From: Jennifer Campbell [Jennifer.Campbell@mdc.mo.gov]
Sent: 12/4/2019 4:18:14 PM
To: Dunn, John [Dunn.John@epa.gov]
CC: Madden, Venessa [Madden.Venessa@epa.gov]; Curtis, Glenn [curtis.glenn@epa.gov]; karen_herrington@fws.gov; Hackler, Pam [pam.hackler@dnr.mo.gov]
Subject: RE: Comments on Ameren Labadie 316(a) Variance Request
Attachments: EPA_comments Labadie 316(a) _two of 2.pdf

From: Dunn, John [mailto:Dunn.John@epa.gov]
Sent: Wednesday, December 04, 2019 9:41 AM
To: Hackler, Pam <pam.hackler@dnr.mo.gov>
Cc: Wieberg, Chris <chris.wieberg@dnr.mo.gov>; Michael Abbott - MDNR <michael.abbott@dnr.mo.gov>; heather.peters@dnr.mo.gov; karen_herrington@fws.gov; Jennifer Campbell <Jennifer.Campbell@mdc.mo.gov>; Madden, Venessa <Madden.Venessa@epa.gov>; Curtis, Glenn <curtis.glenn@epa.gov>
Subject: Comments on Ameren Labadie 316(a) Variance Request

EPA has two sets of comments on the proposed variance. Comments on the Biological Study are attached, and NPDES permit based comments are below:

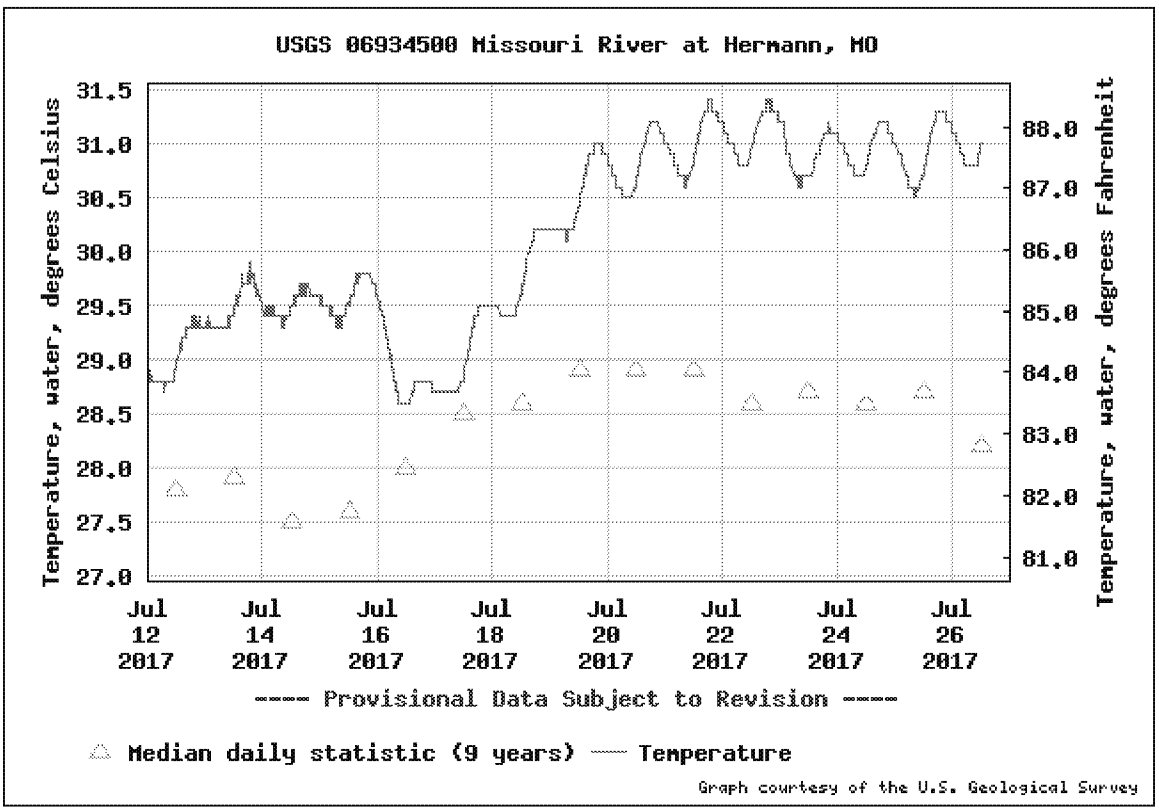
Equations for deriving TDP are calculated to many significant digits but monitoring in the current permit is only required once daily. During heat events, stream temperature can vary by up to 1.5°F in a given day. See 2017 data in the graph below.

The permit should assure that monitoring precision matches up with the detailed nature of the modeling. It should be noted that the USGS gage at Hermann, the data source for the permit, monitors Flow and Temperature every 15 minutes. Temperature can be measured inexpensively by calibrated thermistors feeding data to a computer that calculates TDP and estimated temperature at the edge of the RMZ. Continuous monitoring at this frequency would generate unneeded data, but high frequency monitoring when variance conditions are approached could create important data sets for future consideration. In any case, all data used in the model equations should be time synchronized.
